# RESPONSES TO COMMENTS on the Draft Environmental Impact Report

### Central SoMa Plan

PLANNING DEPARTMENT CASE NO. **2011.1356E**

Re: Attached Responses to Comments on Draft Environmental Impact Report:

Figure RTC-1 Existing, Proposed, and Revised Height and Bulk Map for Block 3762

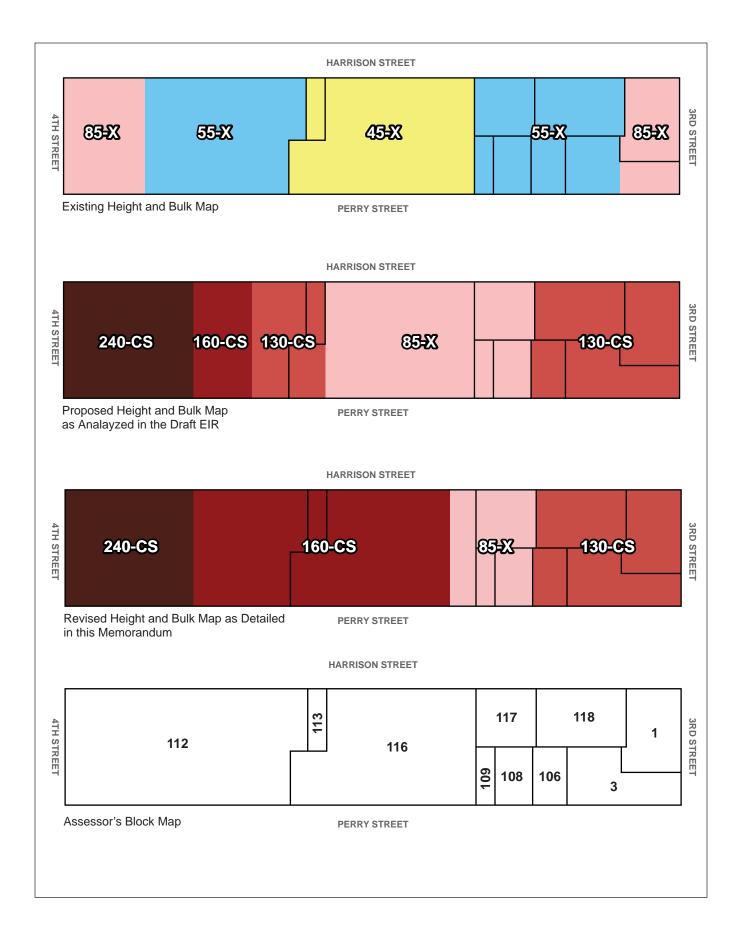
The Planning Department proposes to alter the proposed Height and Bulk Map from that analyzed in the Draft EIR for a portion of the block bounded by Harrison, Third, Bryant, and Fourth streets. Specifically, the proposal entails extending a 160-CS Height and Bulk District to encompass most of the mid-block area including the eastern half of Lot 112 and all of Lots 113 and 116 within Block 3762. The Draft EIR evaluated the western portion of this mid-block change as a 130-CS Height and Bulk District and the eastern portion as an 85-X Height and Bulk District. See **Figure RTC-1**, **Existing**, **Proposed**, **and Revised Height and Bulk Map for Block 3762**, which depicts the existing height of the block, the proposed heights analyzed in the Draft EIR, and the revised heights now proposed. Draft EIR **Figure II-7**, **Proposed Plan Area Height and Bulk Districts [Revised]**, and **Figure II-8**, **Generalized Height Limits**, **Existing and Proposed Height and Bulk Districts [Revised]**, are also revised to show the changes.

Based on the foregoing, the revisions to the Draft EIR Height and Bulk Map (Draft EIR Figure II-7, p. II-19) would not result in any new or substantially more-severe significant aesthetic impacts than identified in the Draft EIR.

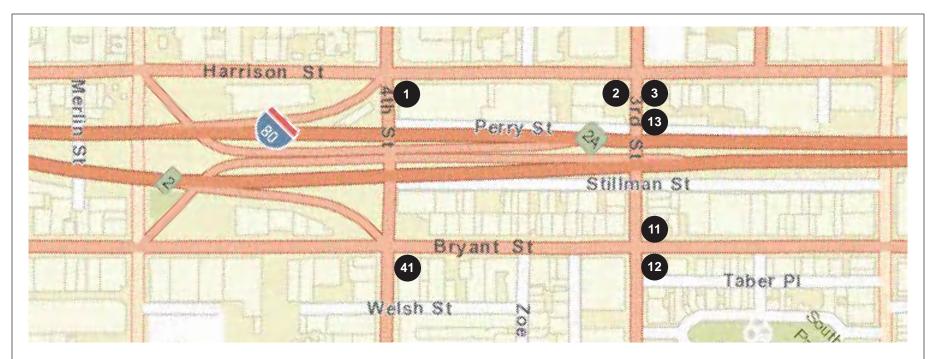
Programmatic wind-tunnel testing for the Draft EIR was undertaken at the Plan level, based on the same building masses as evaluated in the visual simulations, including the revised simulations presented in this RTC document.<sup>7</sup> In the vicinity of the proposed changes to the Height and Bulk Map, wind test points were located at the following seven locations<sup>8</sup> (see **Figure RTC-2**, **Wind Tunnel Test Points near Block 3762**):

- The southeast corner of Fourth and Harrison streets (at the base of the aforementioned proposed 240-foot-tall tower), Test Point 1;
- The southwest and southeast corners of Third and Harrison streets, Test Points 2 and 3, respectively;
- The northeast and southeast corners of Third and Bryant streets, Test Points 11 and 12, respectively;
- The southeast corner of Third and Perry streets, Test Point 13; and
- The southeast corner of Fourth and Bryant streets, Test Point 41.

No test points were immediately adjacent to the Harrison Street frontage where the Height and Bulk Map changes are proposed; the closest points are those at Fourth and Harrison and at Third and Harrison streets. Existing conditions at the seven test points noted above are moderately windy, with the wind speed that is exceeded 10 percent of the time, or wind comfort speed, ranging from 6 miles per hour (mph) to 19 mph.<sup>9</sup> (In general, conditions in SoMa are less windy than in very windy locations in San Francisco, such as the Van Ness and Market area.) Of the seven test points, the Draft EIR wind-tunnel testing found that Plan Area development would alter the wind comfort speed by 1 to 5 mph. Wind speed would decrease at five of the seven points and would increase at two locations—the southwest and southeast corners of Third and Harrison streets—by 3 mph. Wind speeds do not currently exceed the Planning Code's hazard criterion of 26 mph for one full hour of the year at any of the seven locations under existing conditions and would not do so under conditions with Plan development.

Based on the foregoing, the revisions to the Draft EIR Height and Bulk Map (Draft EIR Figure II-7, p. II-19) would not result in any new or substantially more-severe significant wind impacts than identified in the Draft EIR.

Figure IV.H-20

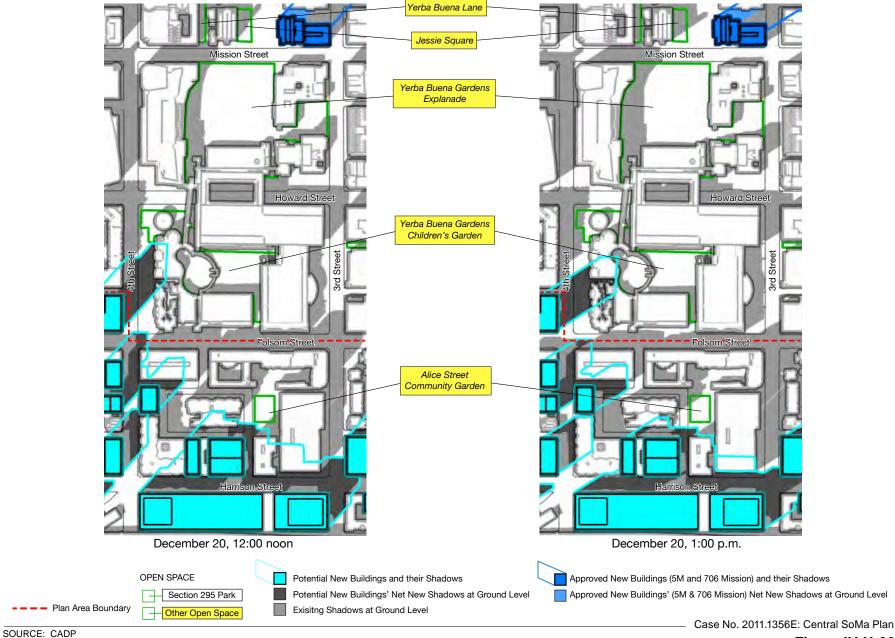
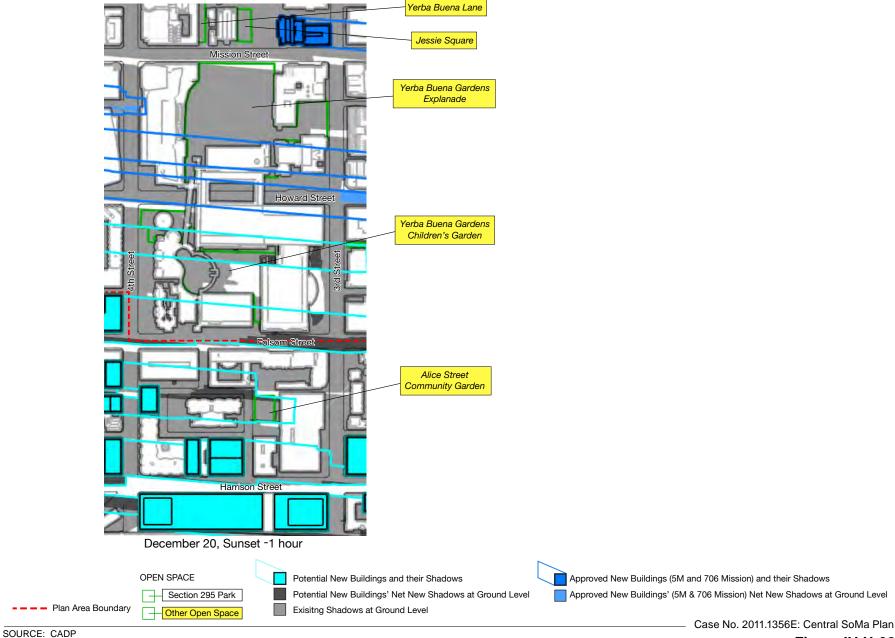
To incorporate the shadow effect of changes in the Height and Bulk Map, Draft EIR Figure IV.H-2 through Figure IV.H-10, pp. IV.H-12 through IV.H-20, and Figure IV.H-17 through Figure IV.H-22, pp. IV.H-23 through IV.H-34, have been revised and are presented here. In many cases, there is no change to the shadow patterns depicted in the Draft EIR because the change in the Height and Bulk Map would not result in new or different shadows. As with the Draft EIR, the complete set of figures produced by the computer modeling is included in a revised Draft EIR Appendix E, which is included in this RTC document.

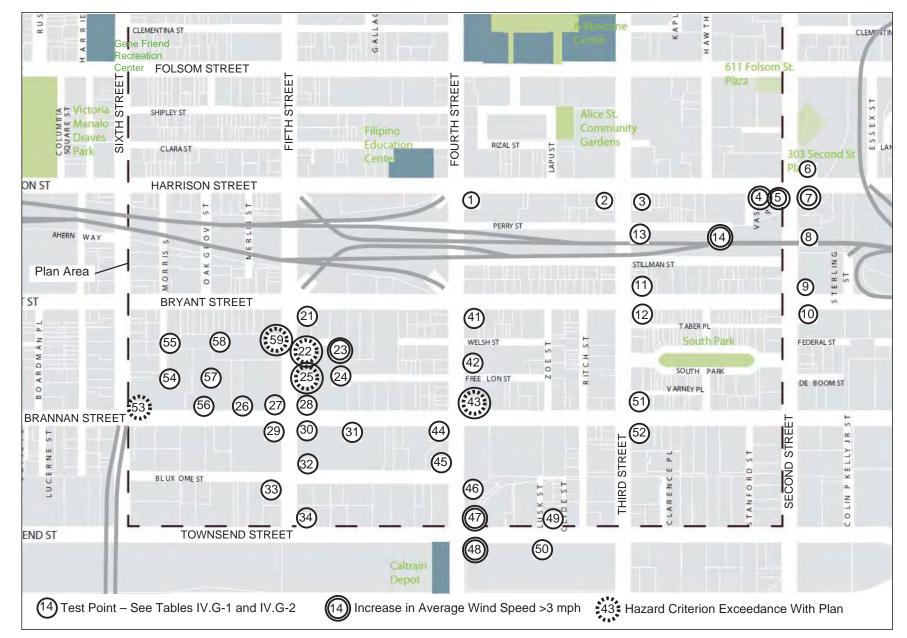
"IV.G-16 <u>Conclusion.</u> This section states that the Plan could result in four (4) new exceedances of the 26-mph hazard criterion, but Figure IV.G-3 shows only three exceedances. Please clarify." (Melinda A. Sarjapur, Reuben, Junius & Rose, Various Central SoMa Property Owners, Letter, February 13, 2017 [O-CSPO.22])

On Draft EIR p. IV-G-14, Figure IV.G-3, Greatest Increases in Wind Speed, is corrected to show a total of five exceedances of the 26 mph wind hazard criterion.

250' Tower Variant: Screened Annual Shadow Fan (factoring in shadow from existing buildings)

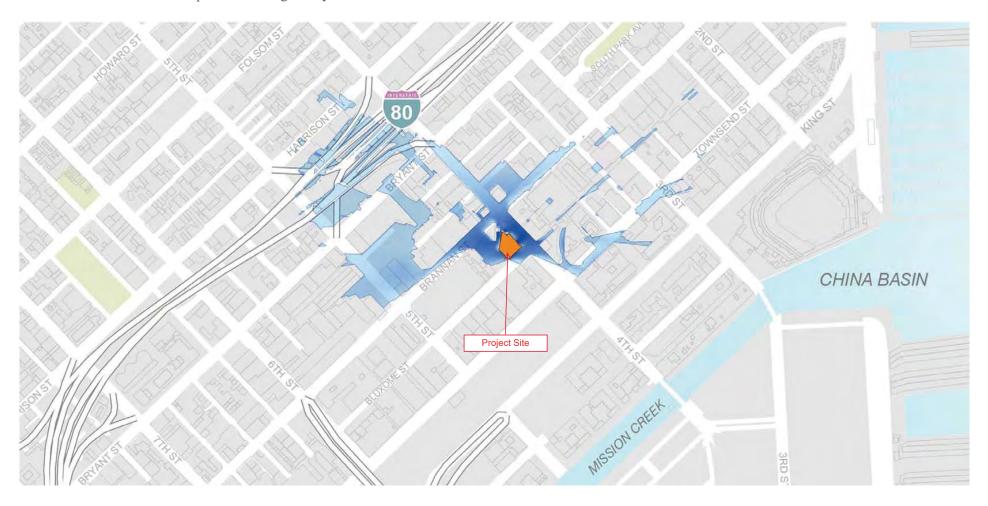
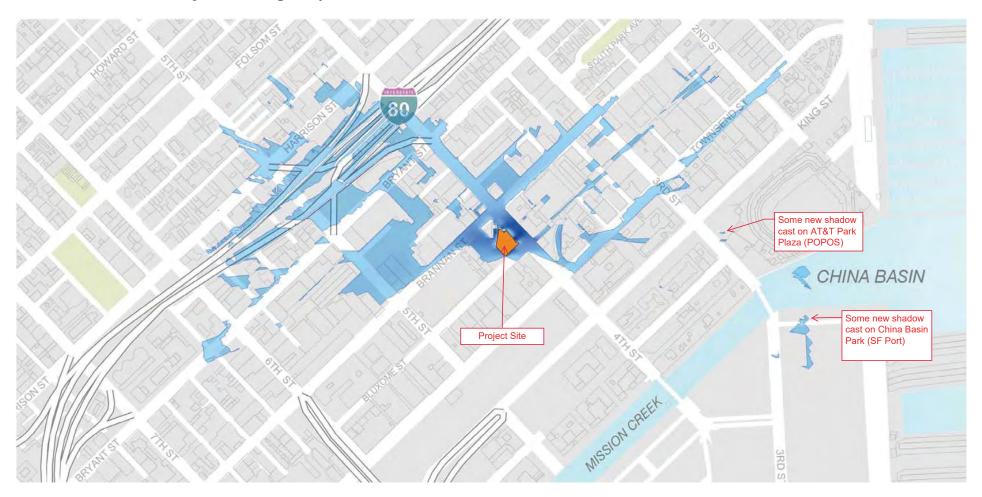
Moreover, any such analysis will establish that there is no significant difference in terms of environmental impacts between 250 feet (the height limit indicated in Figure II-7) and at least 350 feet (the proposed height for the Project as described on page IV-8) and will not change the conclusions of the DEIR.

Should the Planning Department believe that a 250-foot height limit for the Project site also be analyzed in the Final EIR, such a lower scale of development is already analyzed in the DEIR as an element of the Reduced Heights Alternative (see DEIR at Figure VI-1).
